6140 SOUTHMOOR DRIVE

SITE DEVELOPMENT PLAN

PURPOSE STATEMENT

THE PURPOSE OF THIS SITE DEVELOPMENT PLAN AMENDMENT IS TO CONSTRUCT A METAL BUILDING AND PAVED PARKING.

COVER SHEET

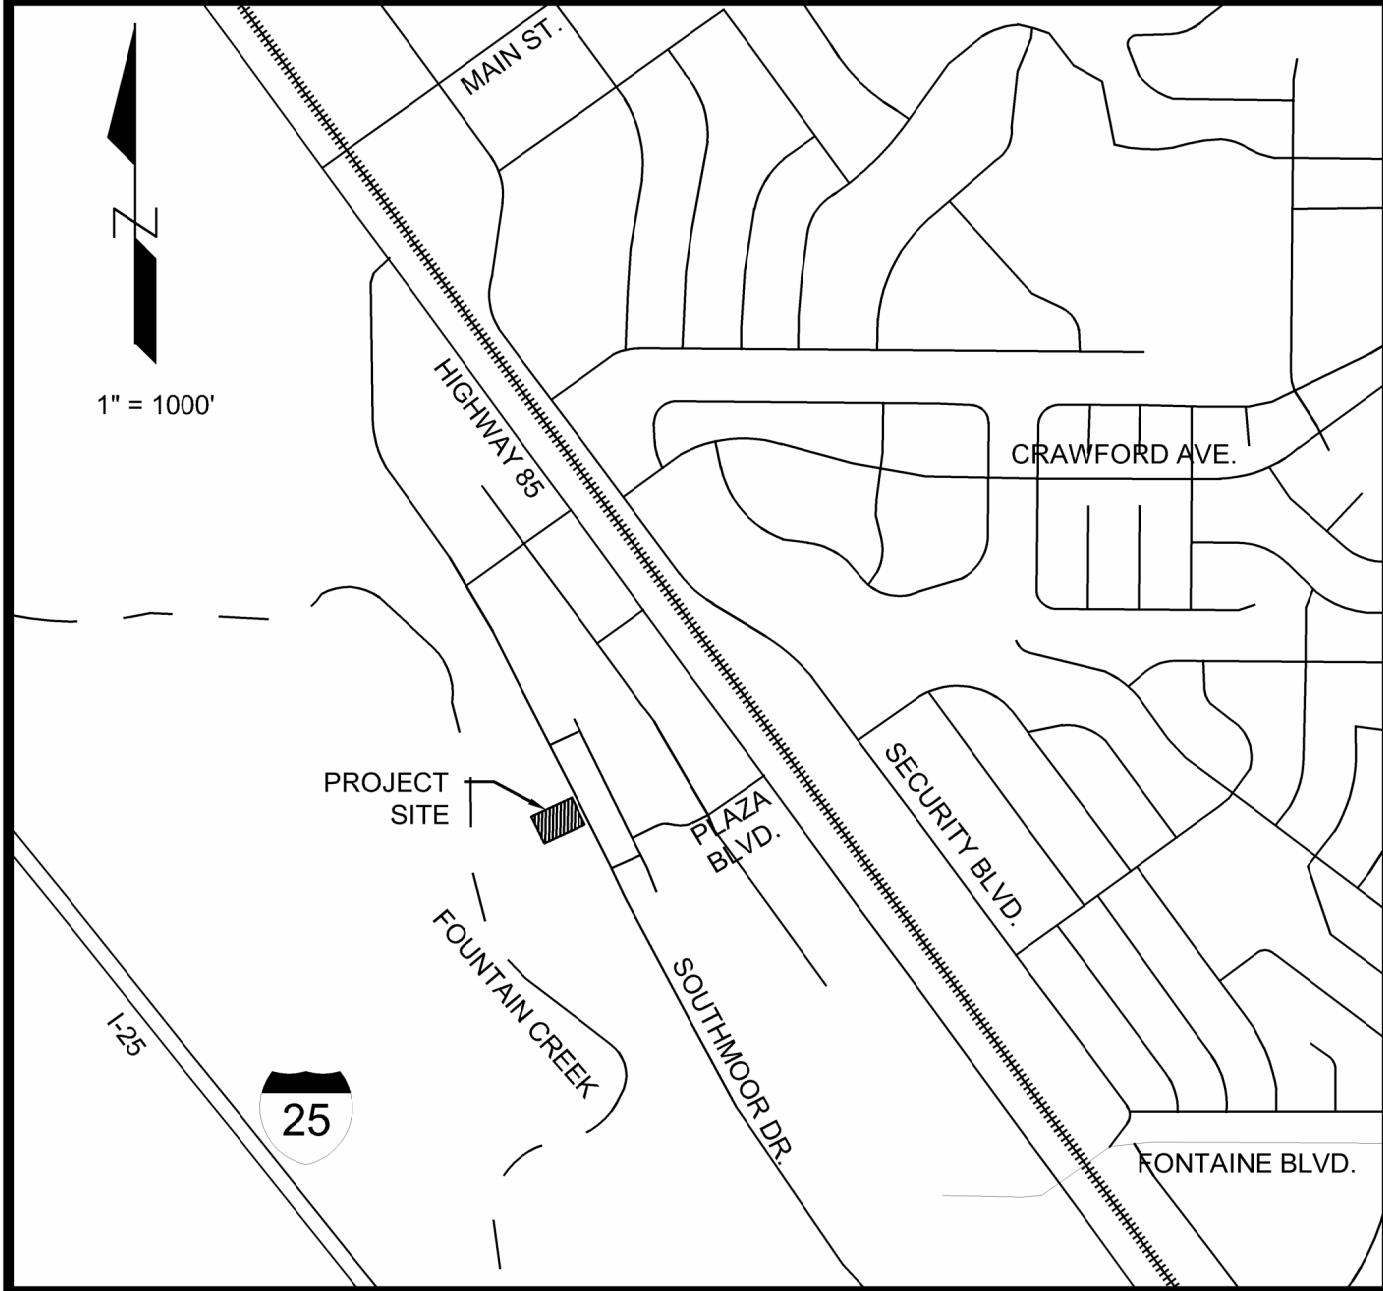
GENERAL NOTE: PLEASE SUBMIT EACH DOCUMENT SEPERATELY, OR REQUEST THAT SLOTS BE AMENDED TO REFLECT SUBMITTAL PACKAGE.

Remove Town of Castle Rock Signature Blocks.

SITE PLAN

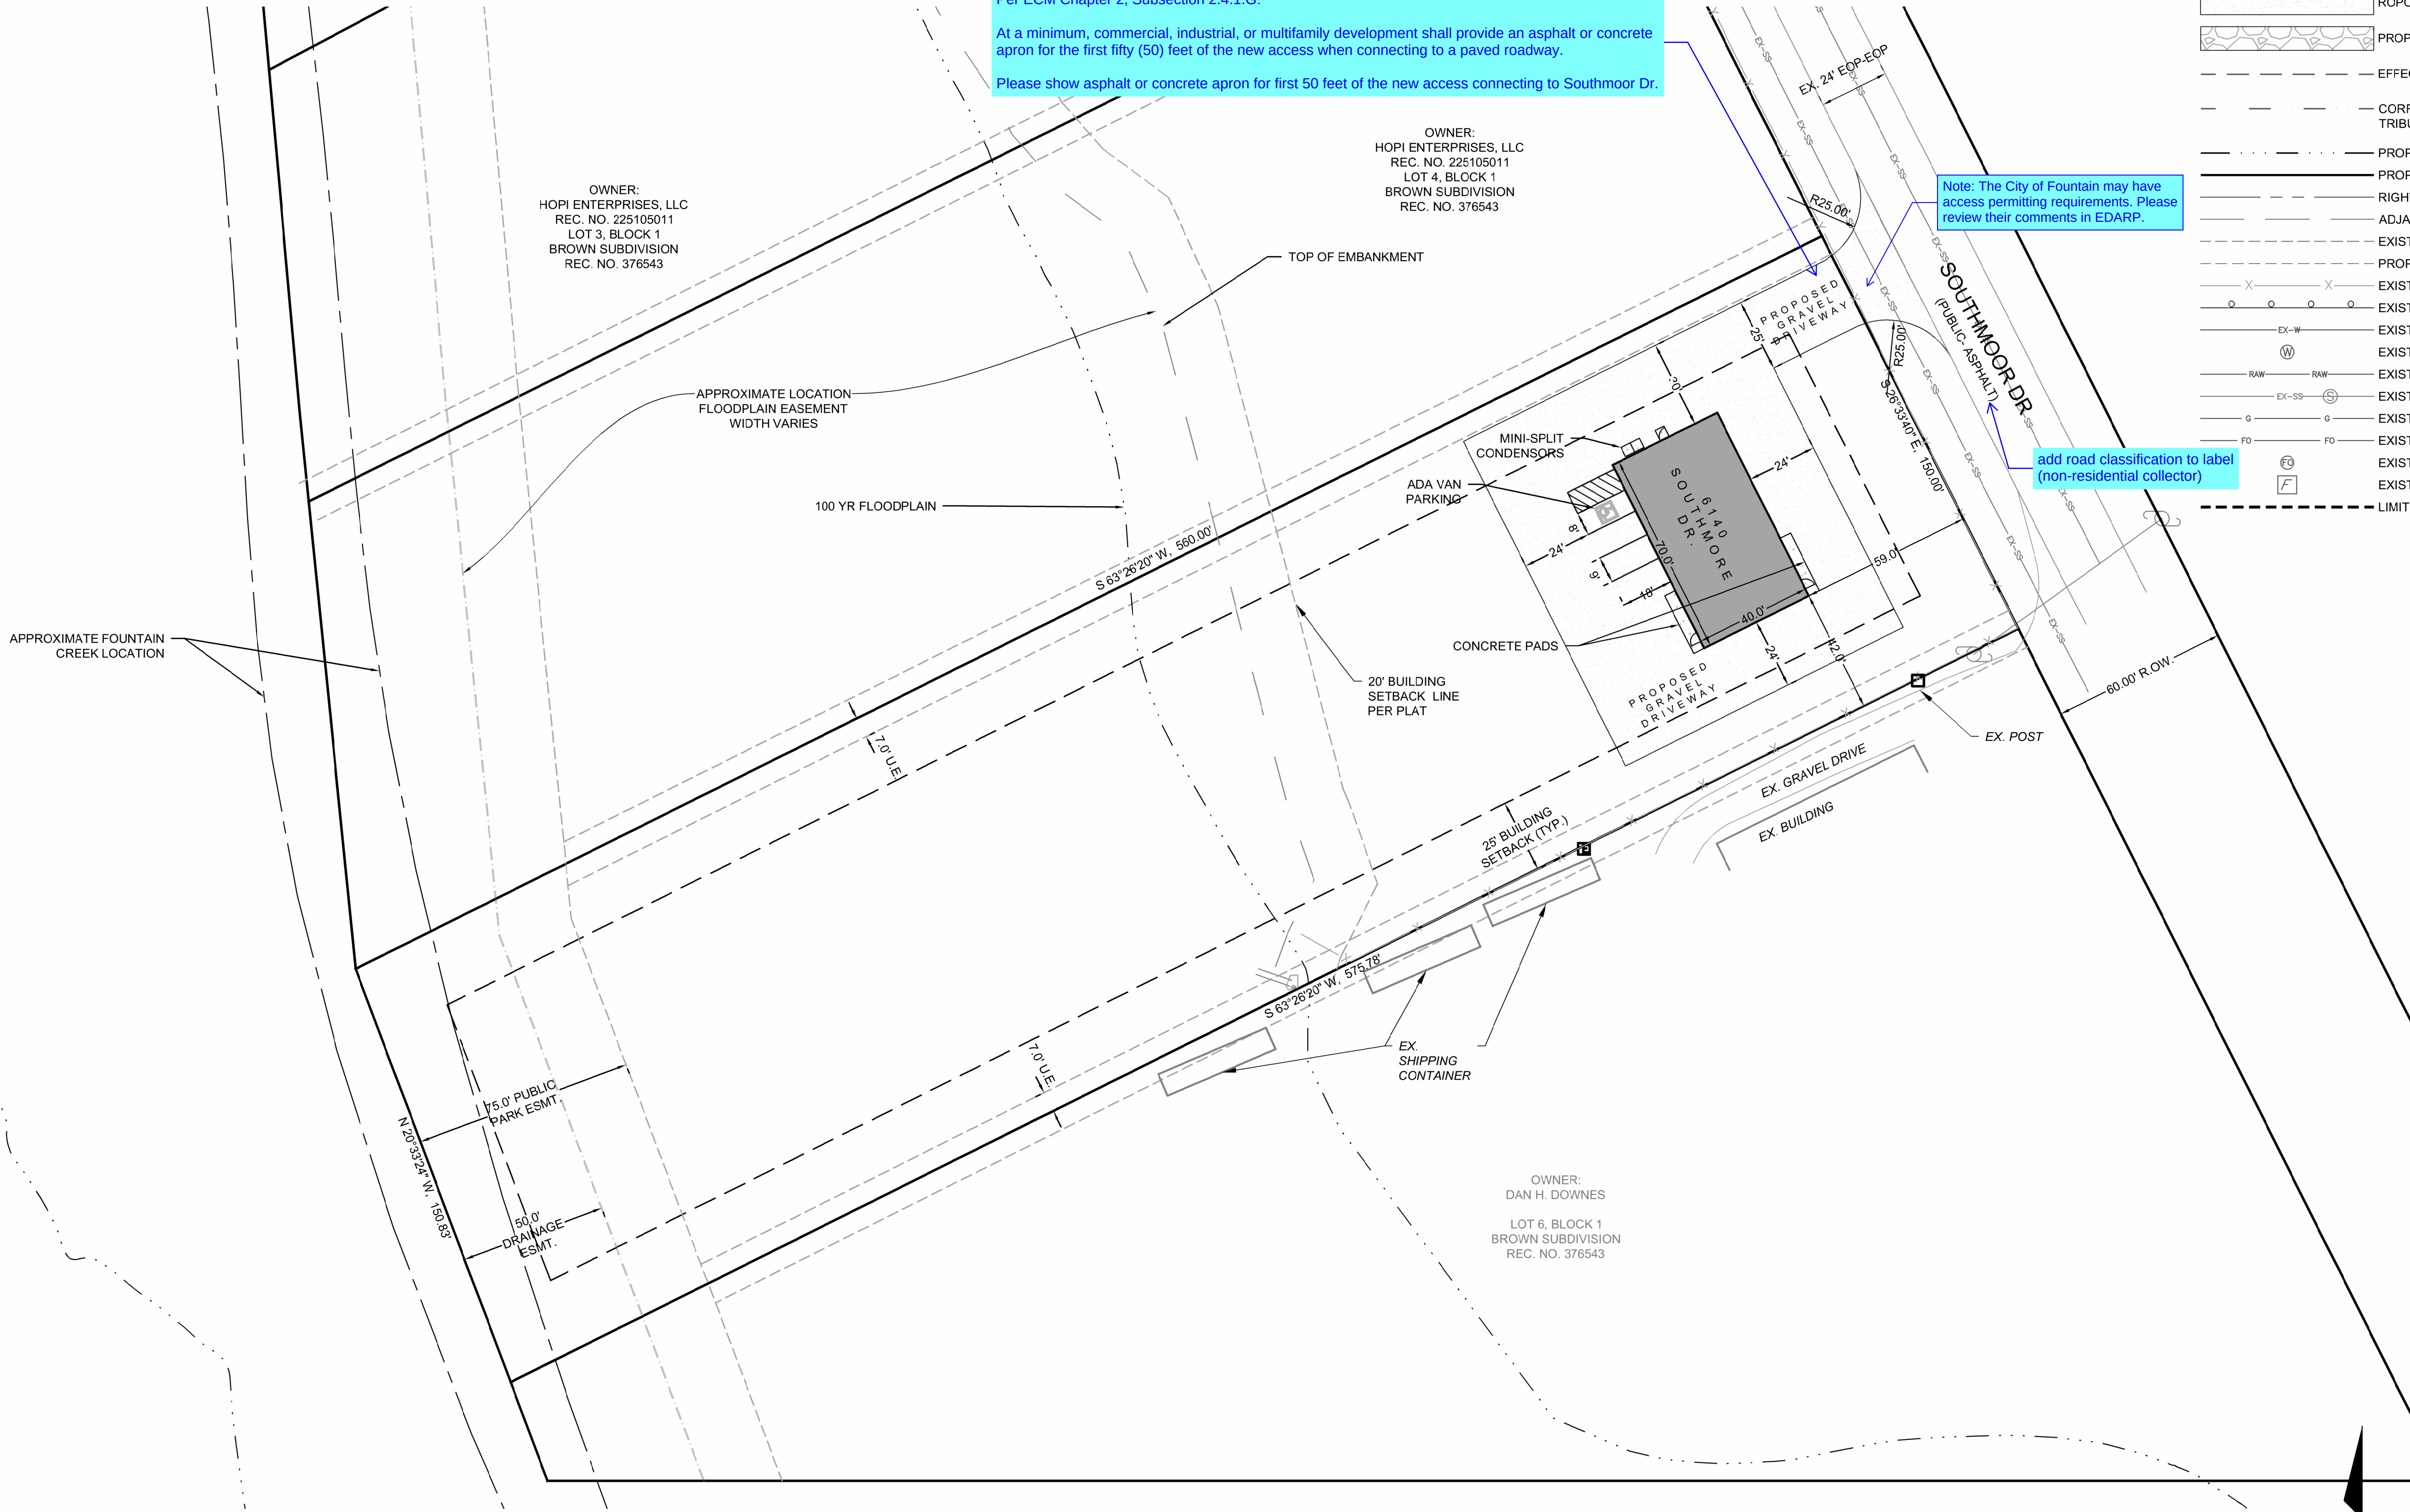
Per ECM Chapter 2, Subsection 2.4.1.G:
At a minimum, commercial, industrial, or multifamily development shall provide an asphalt or concrete apron for the first fifty (50) feet of the new access when connecting to a paved roadway.
Please show asphalt or concrete apron for first 50 feet of the new access connecting to Southmoor Dr.

Note: The City of Fountain may have access permitting requirements. Please review their comments in EDARP.

add road classification to label (non-residential collector)
